UNITED STATES PATENT AND TRADEMARK OFFICE

APPLICATION NO.	FILING DATE	FIRST NAMED INVENTOR	ATTORNEY DOCKET NO.	CONFIRMATION NO.
09/530,303	04/27/2000	CHRISTOPHER R KING		5407

Office Action Summary

DETAILED ACTION

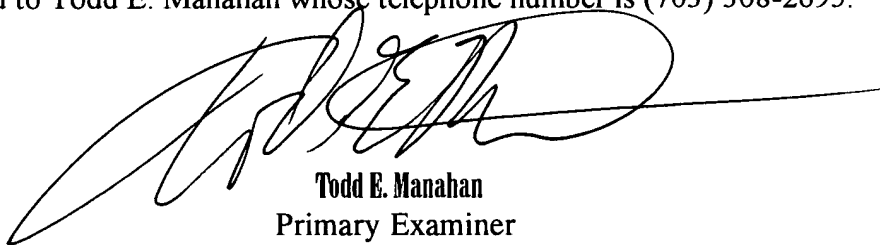
Matsumura discloses a hair processing device which isolates small numbers of hairs between projections. The projections comprise tine assemblies 1, 3, and form stationary channels therebetween. The tine assemblies comprise moving hair handlers or gates shaped to push hairs in a desired direction as set forth in column 2, lines 1-40.
